<p><b>SUNDRY NOTICES AND REPORTS ON WELLS</b>  (DO NOT USE THIS FORM FOR PROPOSALS TO DRILL OR TO DEEPEN OR PLUG BACK TO A DIFFERENT RESERVOIR. USE "APPLICATION FOR PERMIT" (FORM C-101) FOR SUCH PROPOSALS.)</p>		<b>WELL API NO.</b> <b>30-025-23096</b>

5. Indicate Type of Lease <input checked="" type="checkbox"/> STATE <input type="checkbox"/> FEE <input type="checkbox"/>
<p>1. Type of Well: Oil Well <input type="checkbox"/> Gas Well <input checked="" type="checkbox"/> Other <b>SWD</b></p> <p>2. Name of Operator <b>Walsh &amp; Watts Inc</b></p> <p>3. Address of Operator <b>155 Walsh Drive Aledo, TX 76008</b></p> <p>4. Well Location    Unit Letter <b>P</b> : <b>660</b> feet from the <b>S</b> line and <b>660</b> feet from the <b>E</b> line    Section <b>12</b> Township <b>18S</b> Range <b>36E</b> NMPM <b>Lea</b> County <b>Lea</b></p>		6. State Oil & Gas Lease No. <b>332449</b>

7. Lease Name or Unit Agreement Name <b>Lea OR State</b>
		8. Well Number <b>#003</b>
		9. OGRID Number <b>24558</b>
		10. Pool name or Wildcat Junction San Andres
<p>11. Elevation (Show whether DR, RKB, RT, GR, etc.) <b>3789' KB</b></p>

Action 545652

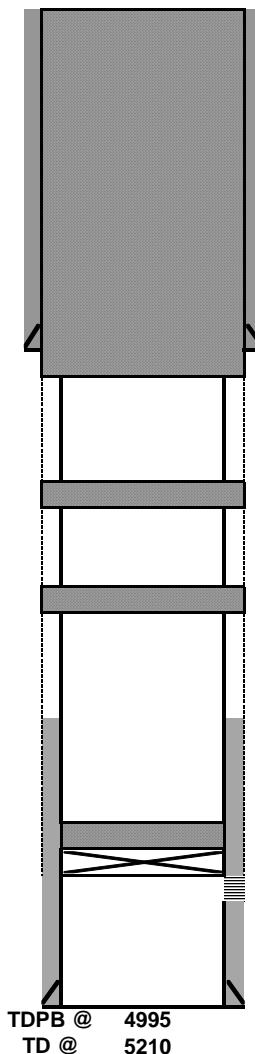
1. Set 5 1/2 CIBP @ 4892'. Circ hole w/ MLF. Pressure test csg **500psi/30min - Run CBL to surface - Spot 40 sx cmt @ 4892-4692'.**
2. Perf & Sqz 80 sx cmt @ 2980-2780'. WOC & Tag (B/Salt)
3. Perf & Sqz 80 sx cmt @ 1800-1600'. WOC & Tag (T/Salt)
4. Perf & Sqz 120 sx cmt @ 400' to surface. (8 5/8" Shoe) - **WOC & Bubble Test**
5. Cut off wellhead, verify cmt at surface, weld on Dry Hole Marker.

**\*\*\*SEE ATTACHED COA's\*\*\*****MUST BE PLUGGED BY 1/1/27**

Created By	Condition	Condition Date
gcordero	Adhere to current Plug & Abandon (P&A) Conditions Of Approvals (COA).	1/23/2026
gcordero	A Cement Bond Log (CBL) is required to be submitted to electronic permitting.	1/23/2026
gcordero	Submit Cement Bond Logs (CBL) prior to submittal of C-103P.	1/23/2026
